FILE NUMBER: PC-26-0007-MA

REQUEST: A proposed map amendment to the Park Hills Zoning Ordinance changing the described area from R-U (Residential Urban) to R-M (Residential Mixed); the applicant is proposing to construct 24 multi-family dwelling units (a net density of 13.29 dwelling units per net acre), which includes the realignment of the intersection of Arlington Road with Dixie Highway, a new public street, and off-street parking areas.

Map Amendment

File Number: PC-26-0007-MA

CONCEPT PLAN		
B&Z WATERCREST, LLC		
STEVEN A. BERLING KY. ENGINEER #18134	SCALE 1" = 30'	DRAWN BY EJB
1504 DIXIE HWY – PARK HILLS KY		
DATE 5/12/26	APPROVED BY	DRAWING NUMBER

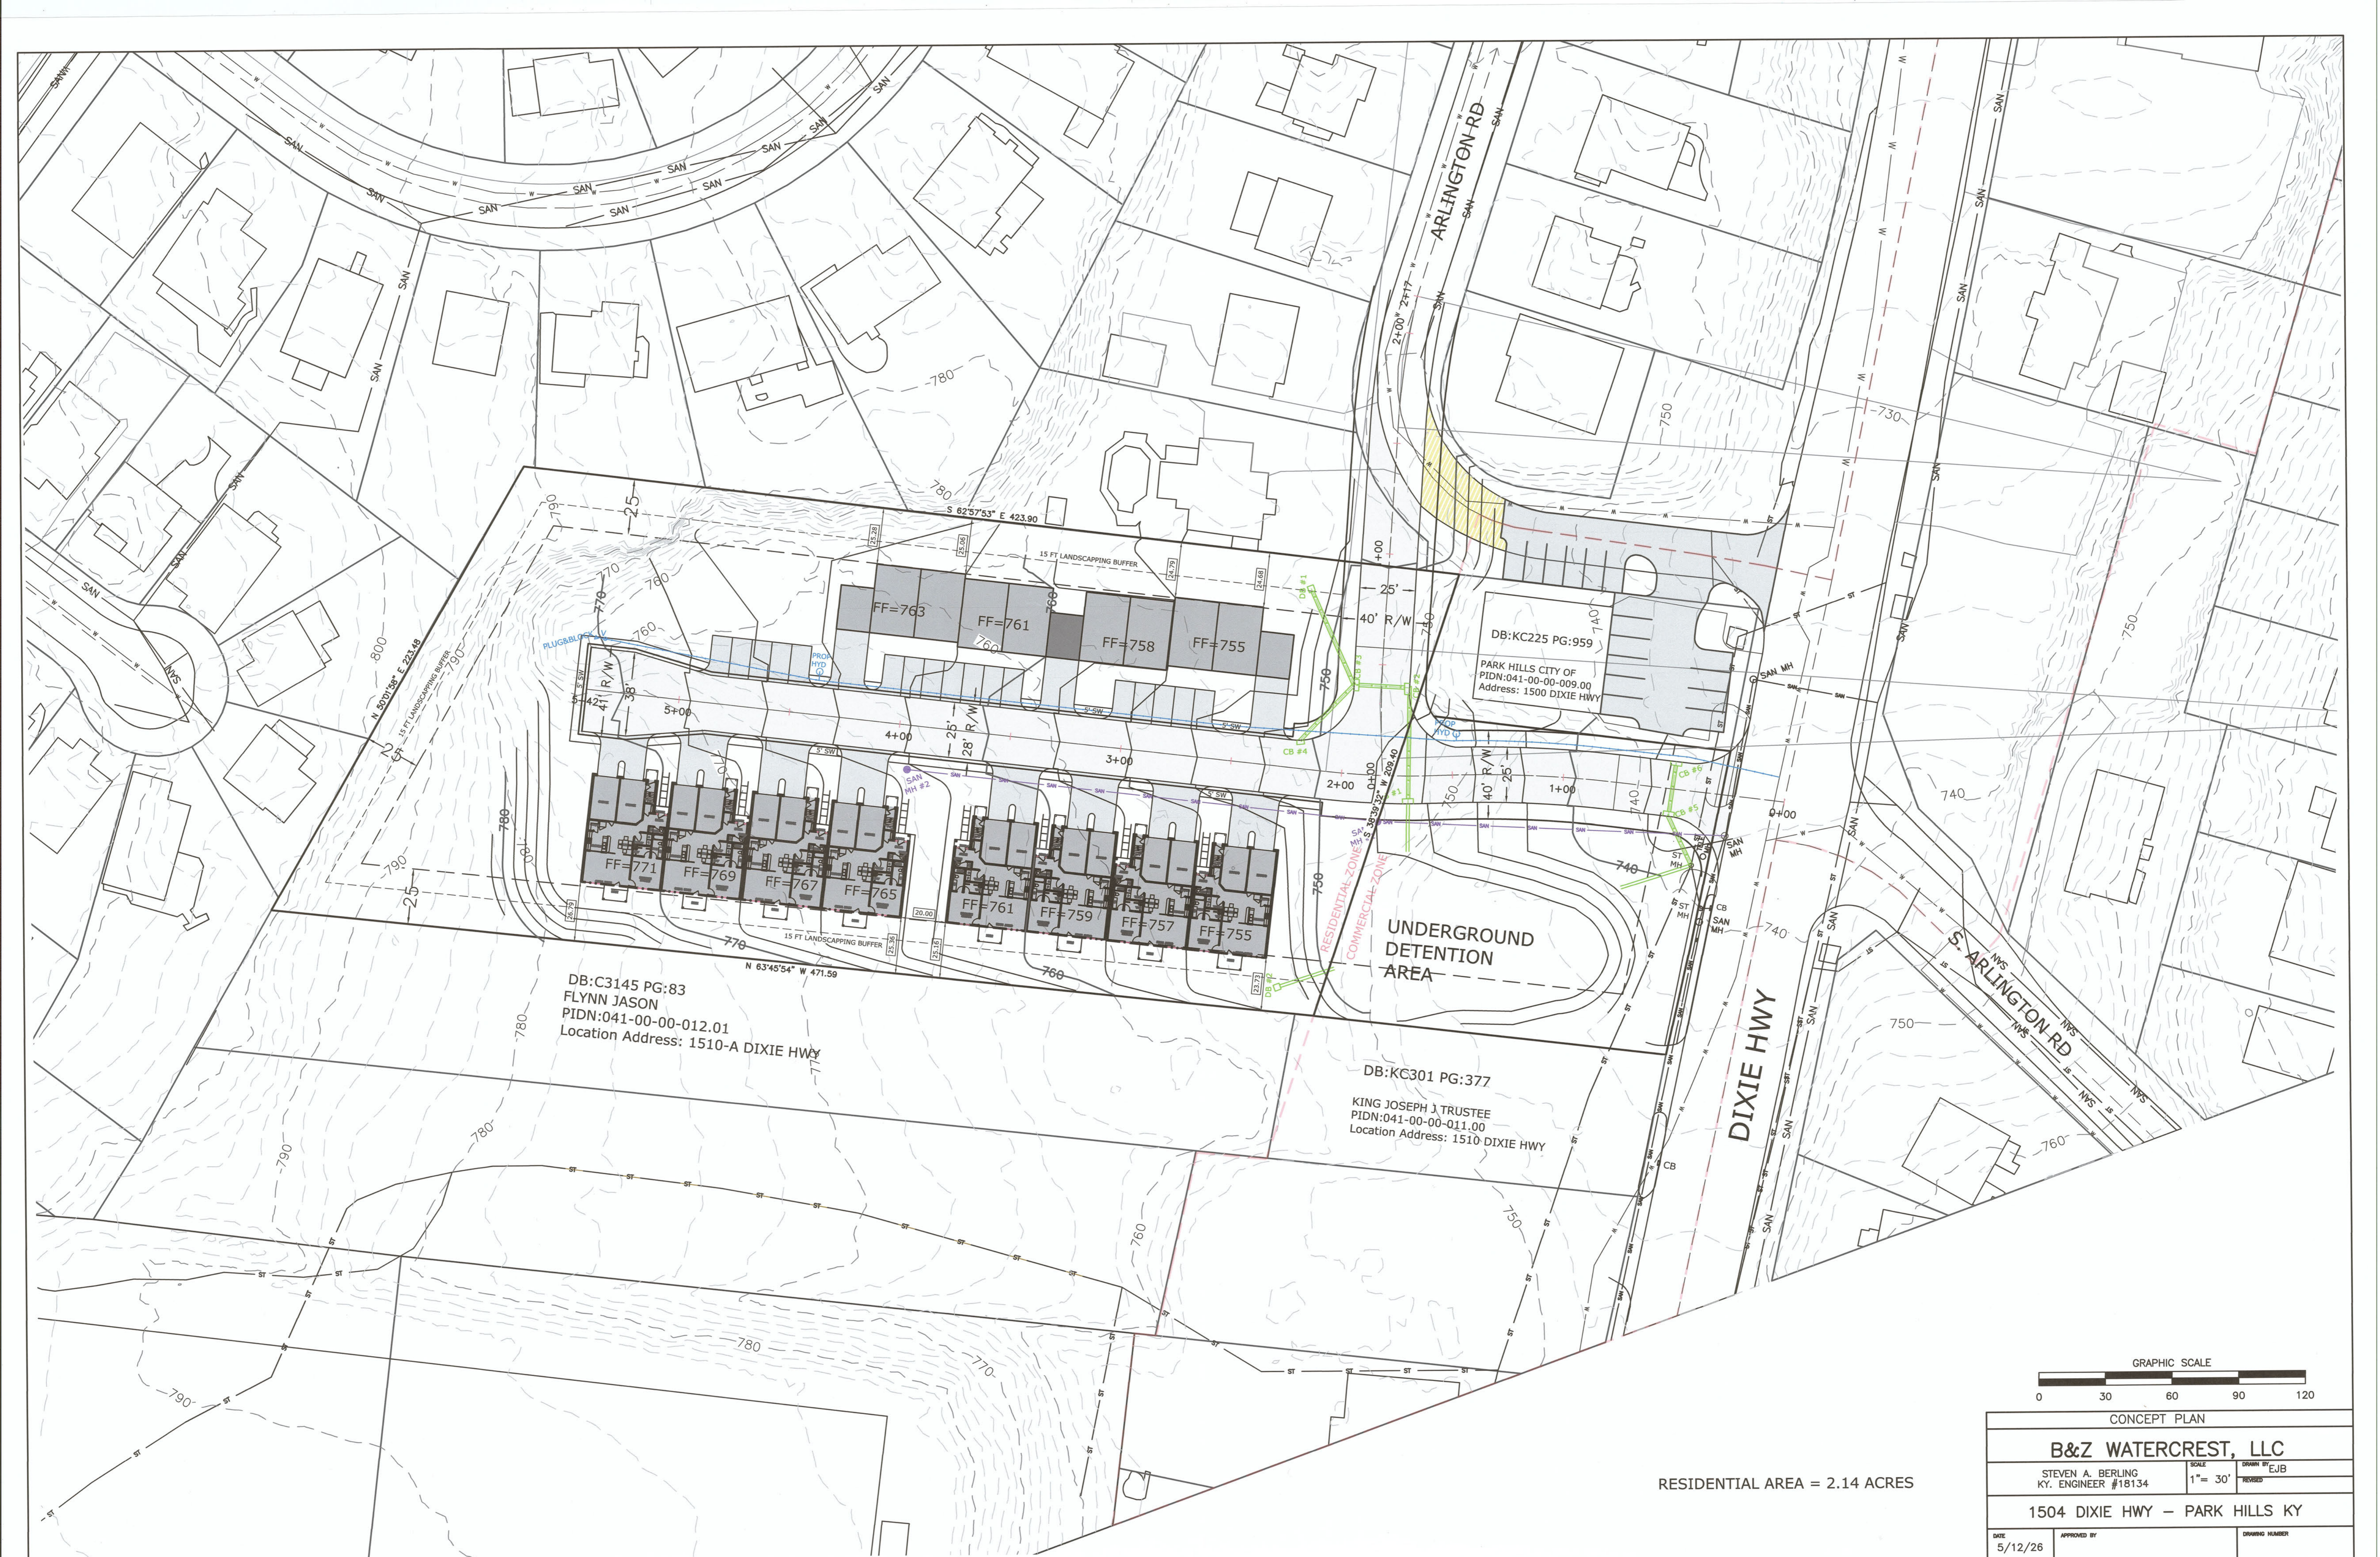
Staff findings: It is unclear on the plans what type of sidewalks are proposed for the realigned Arlington Road. Most of this realignment is located outside of the map amendment area, but there are sections of this roadway located within the map amendment area. The applicant has stated via email that sidewalks will be included on Arlington Road in all areas that are within the map amendment area. These sidewalks will need to be included in future plans. Additionally, although the plan is providing income-aligned housing options for the one-bedroom units, the two and three-bedroom units appear to be closer to the areas of current surplus housing supply.

- g. Article 10 provides requirements for off-street parking. Sufficient information must be provided to show compliance with these regulations. Staff has had discussions with the applicant regarding shifting the site plans to allow additional space for the 17 off-street parking spaces to reduce the need for vehicular overhang. The applicant has indicated that they may adjust the plans, while maintaining all setback and buffering requirements.

- a. Section 4.1-11 requires installation of sidewalks. The applicant must provide sidewalks along Arlington Road.
 - b. Section 4.3-2 of the Kenton County Subdivision Regulations state that all stormwater drainage systems shall comply with the Northern Kentucky Regional Storm Water Management Program Rules and Regulations of Sanitation District No. 1 (SD1's Storm Water Regulations). SD1 reviews developments that disturbs one acre of land or greater. Sufficient information will need to be submitted with the future permits.

I do not have a problem with this style of turnaround. It has proven sufficient on the end of Altavia Ave. However, I would like to see another fire hydrant installed at the new streets entrance and Dixie Hwy. The current hydrant is essential for all of the commercial occupancies on Dixie Hwy. and the distance between 1522 hydrant and Finkes Pub 1458 hydrant would be too great with the removal of Dixie and Arlington. Please let me know if you have any questions.
